ADDENDUM NO. 5

REGIONAL PARK RESTROOMS
PROJECT NUMBER 122013

The following revisions to the Plans shall be made:

DAKOTA SECTIONAL BUILDING NUMBER CR-087
FLR. PLANS, INT. ELEVATIONS, STRUCTURAL AND FOUNDATION DETAILS

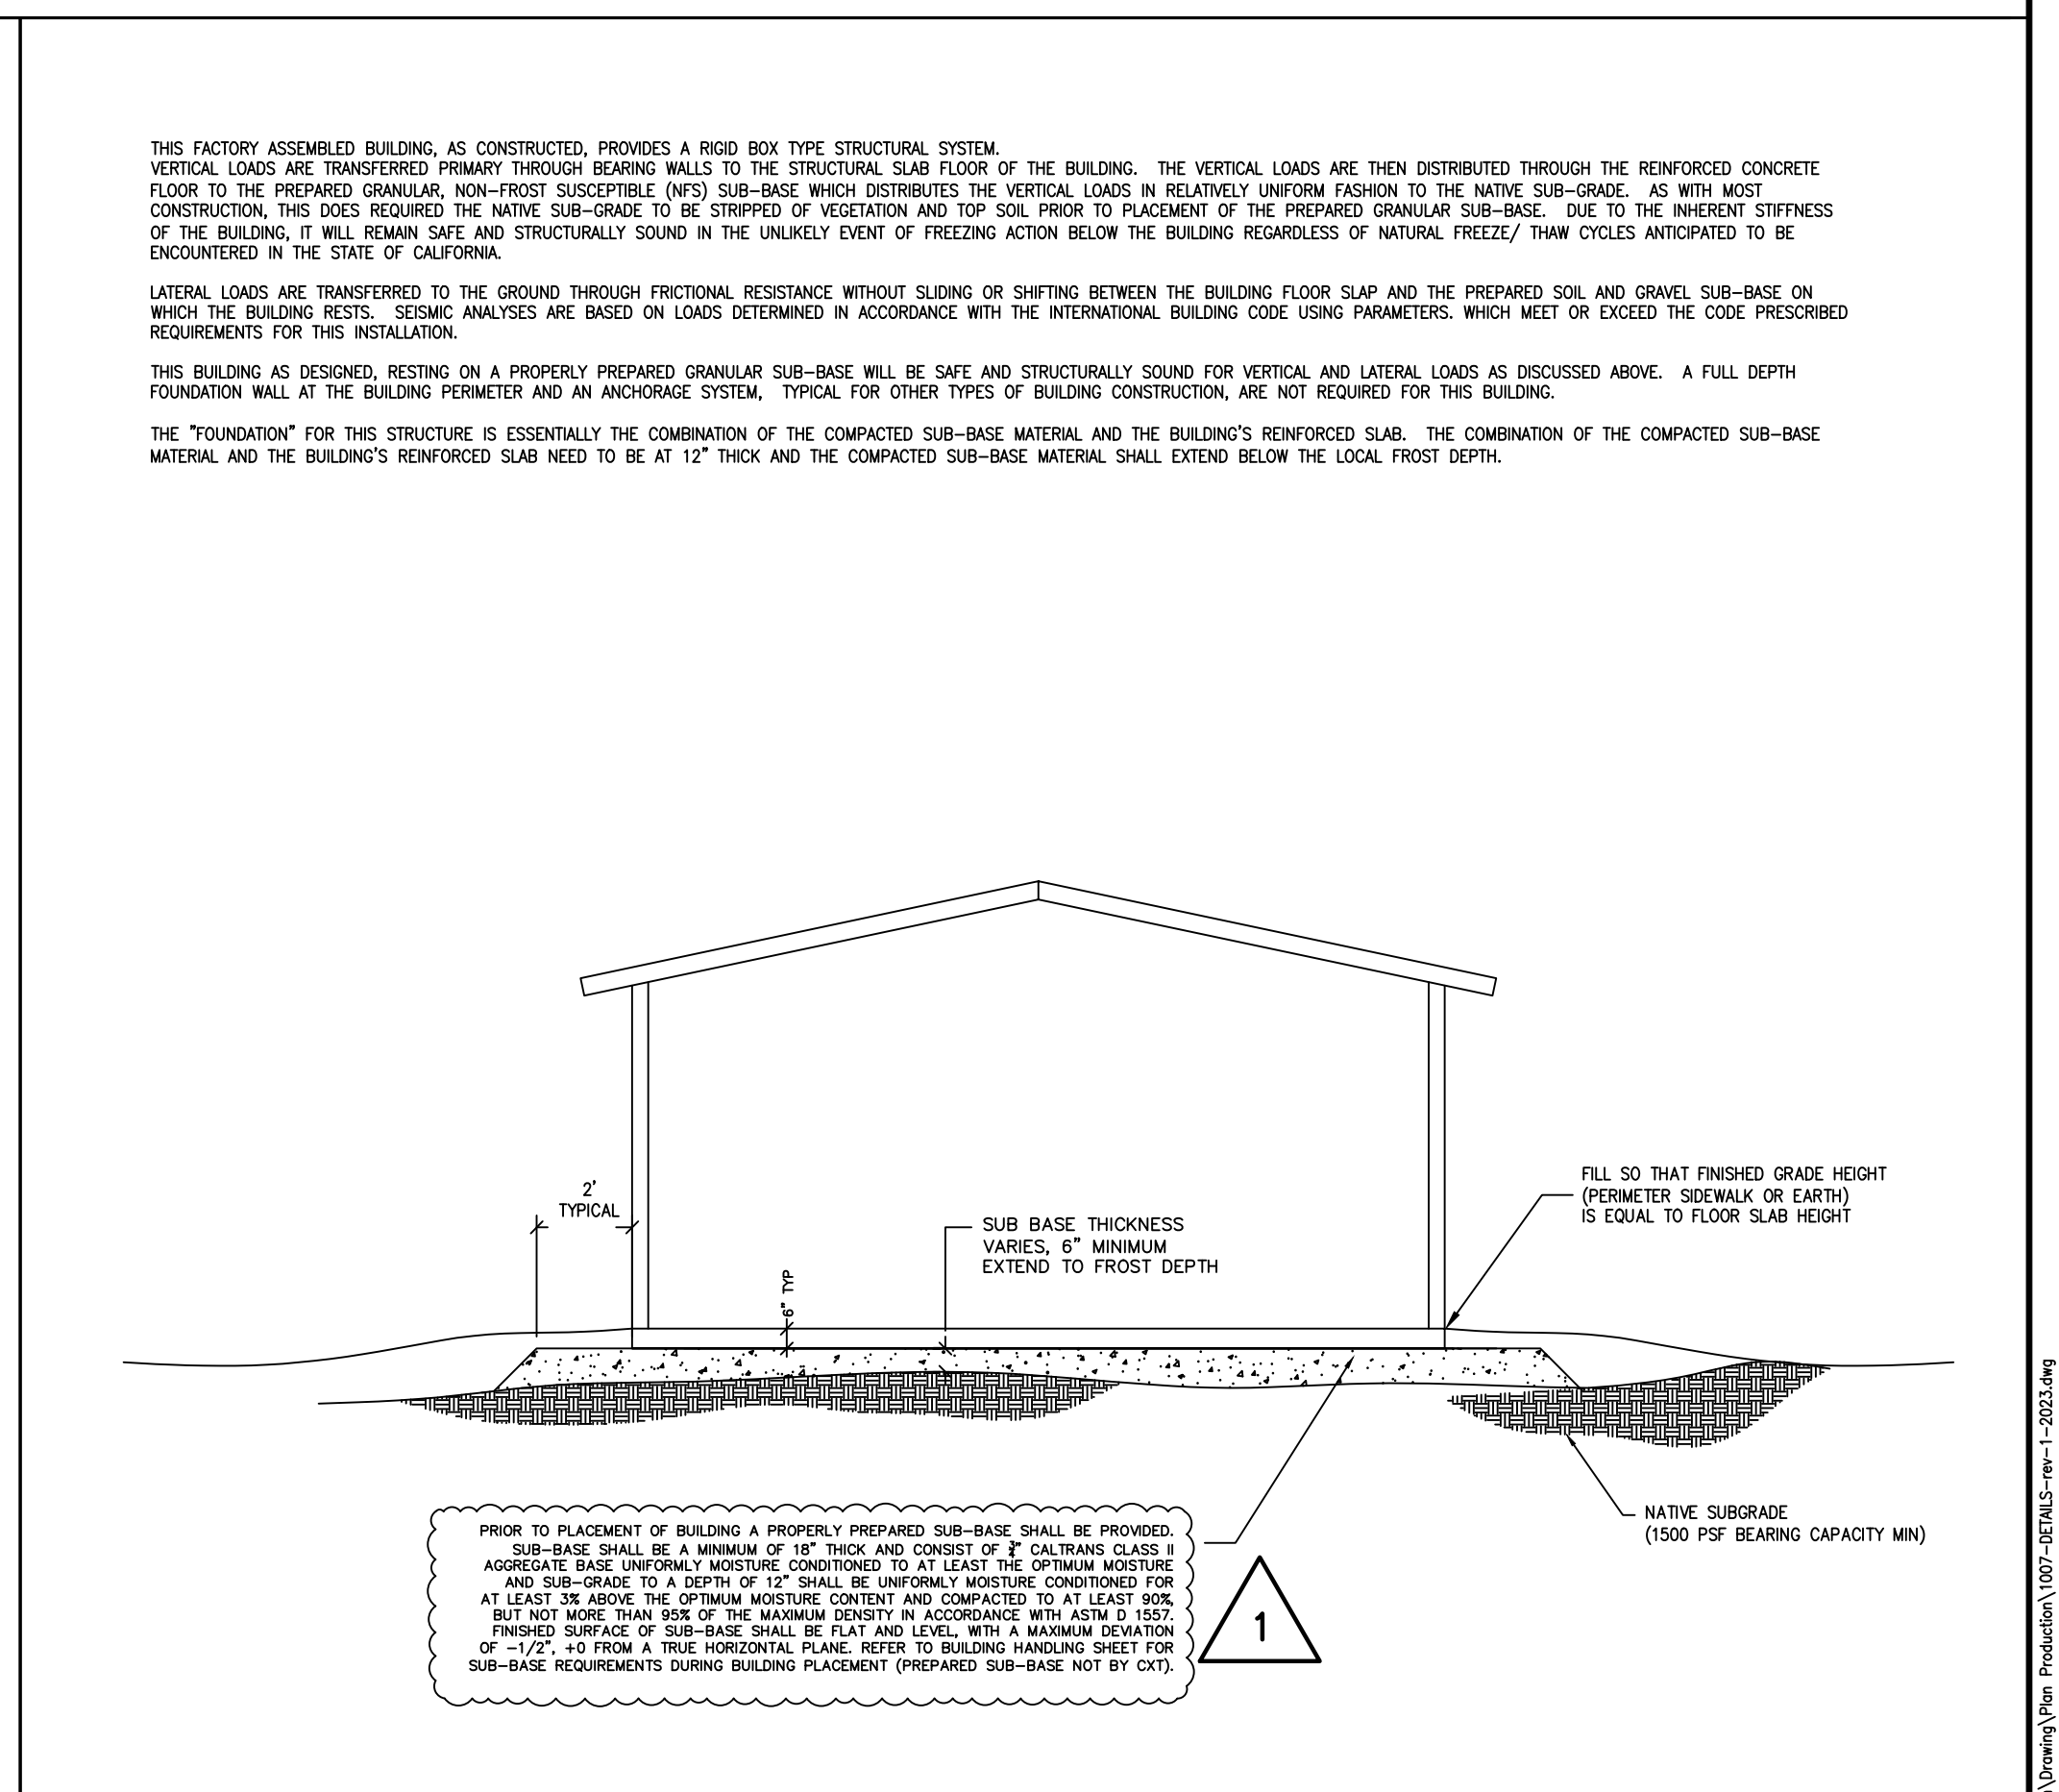
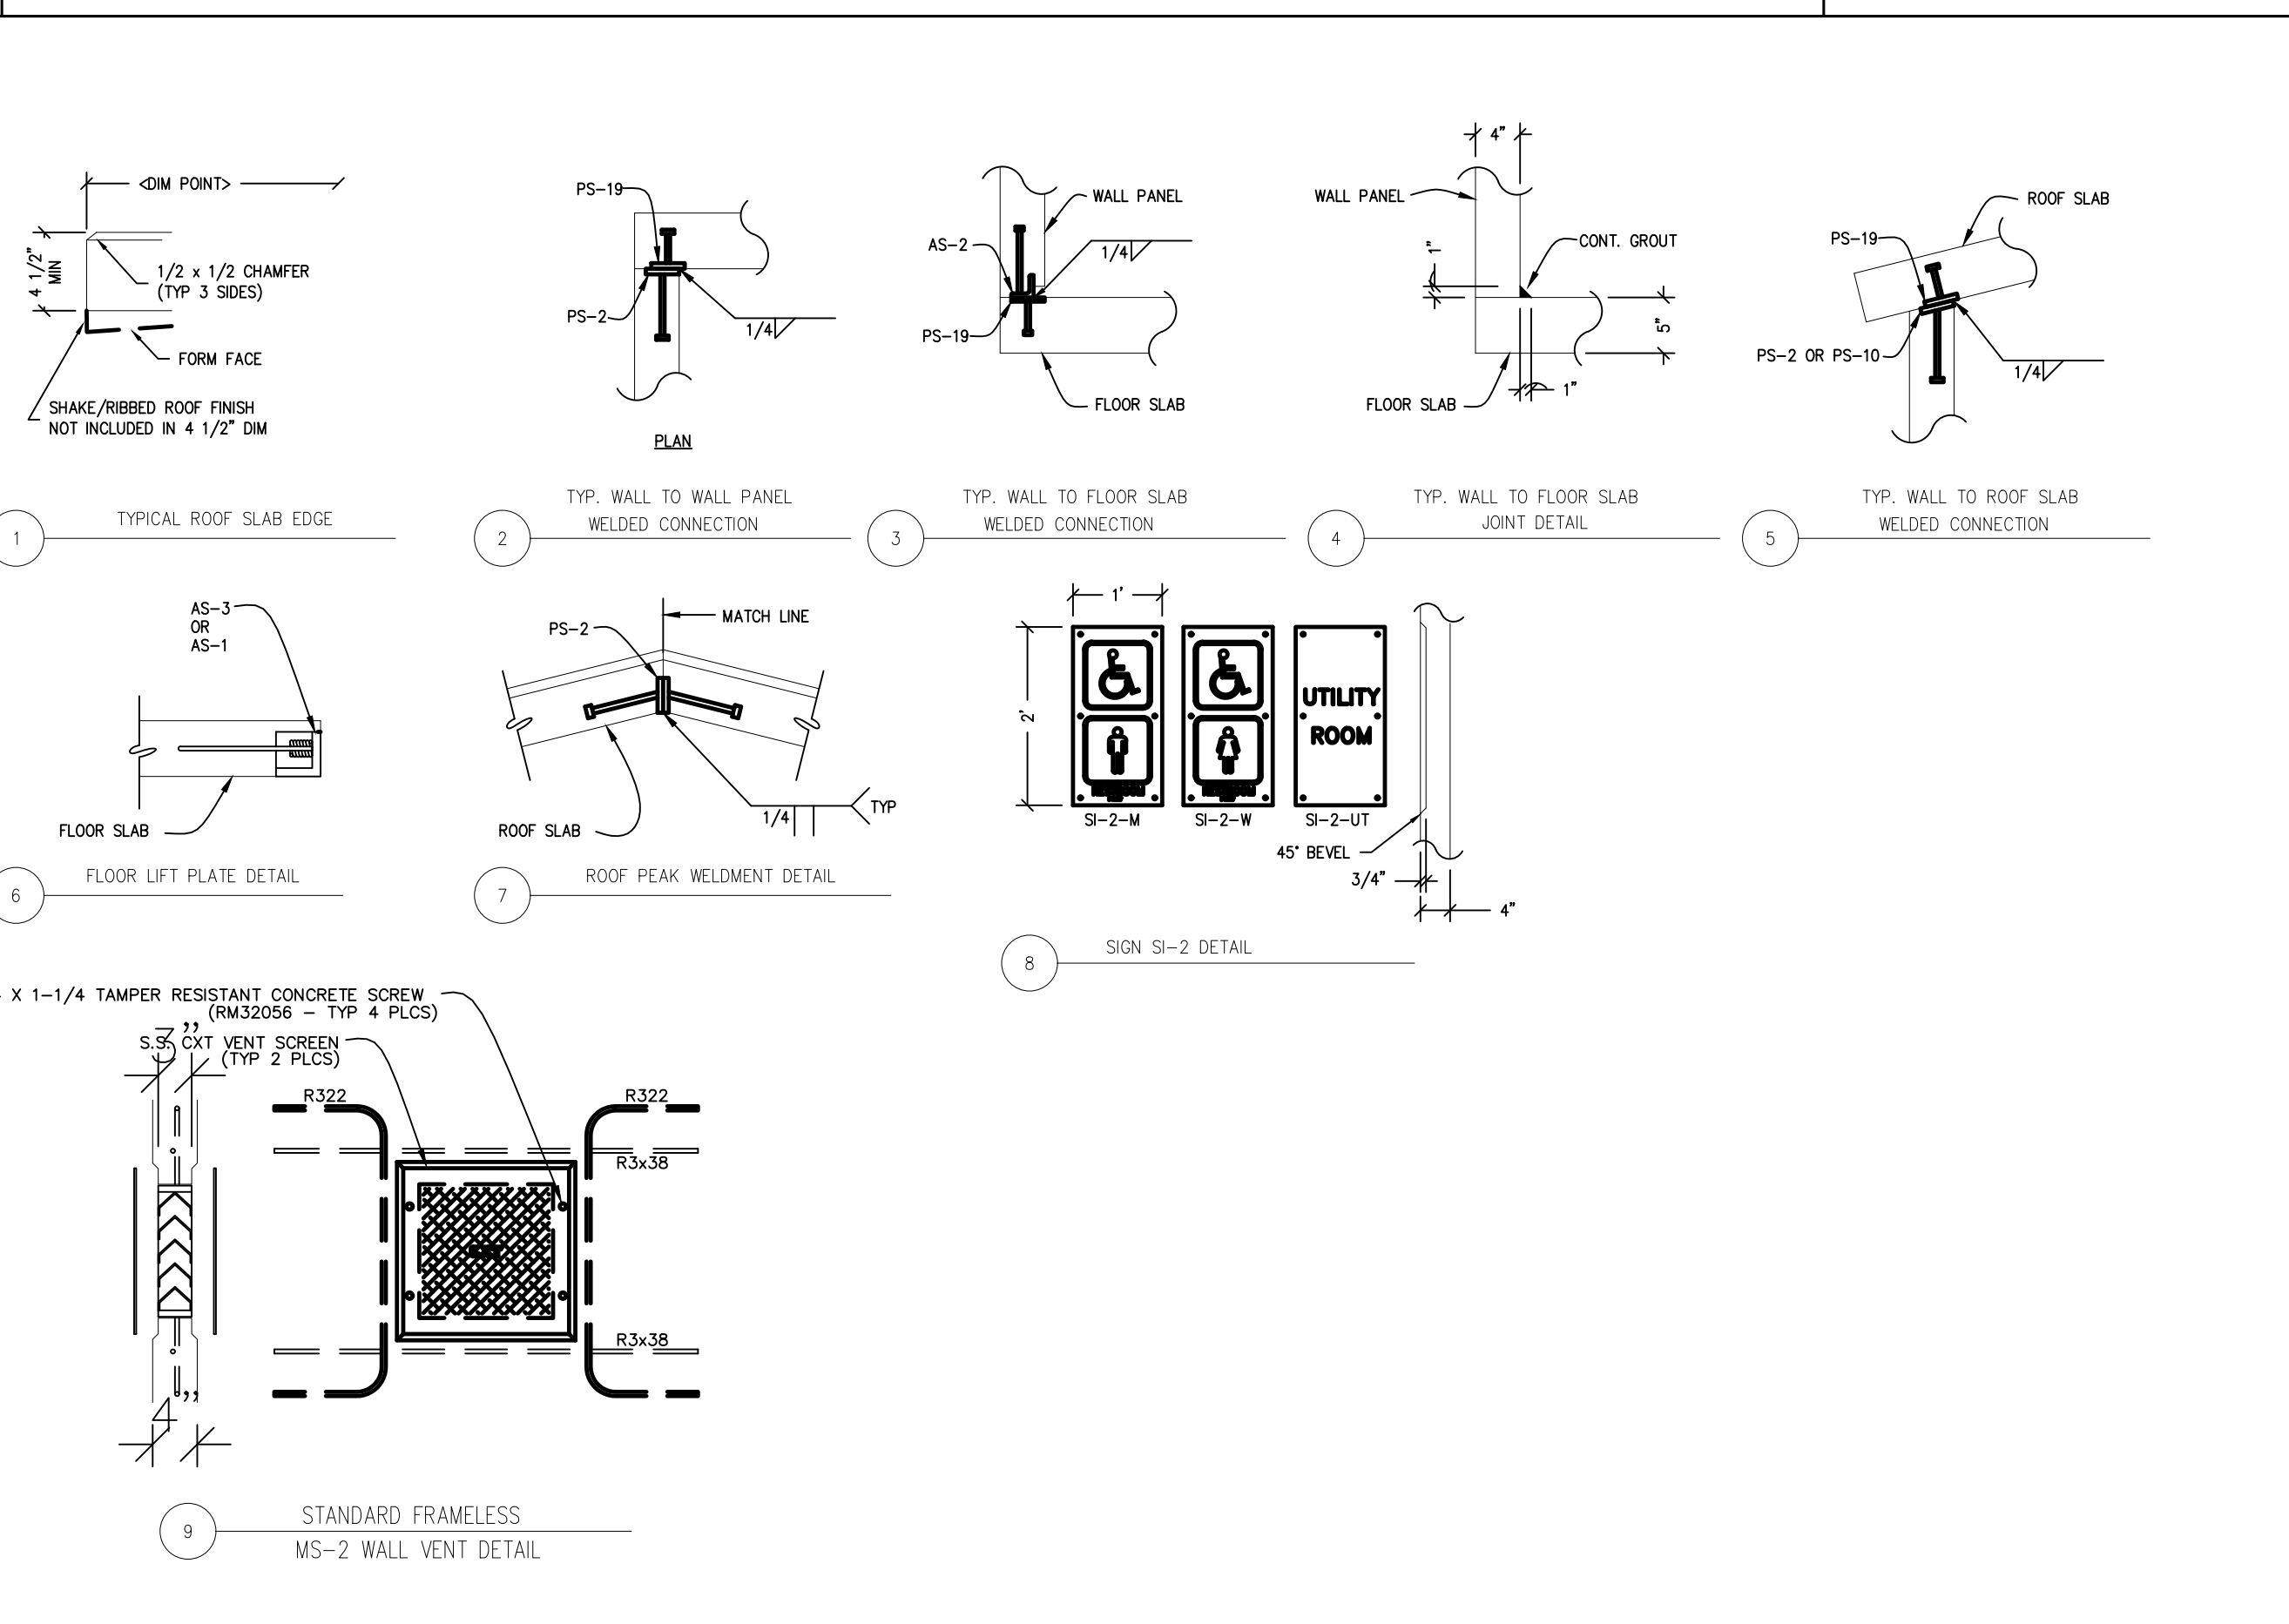
NO.	DATE	BY	REVISION MADE
1	2/22/2023	VM	Added cal trans verbage for sub base and aggregate base
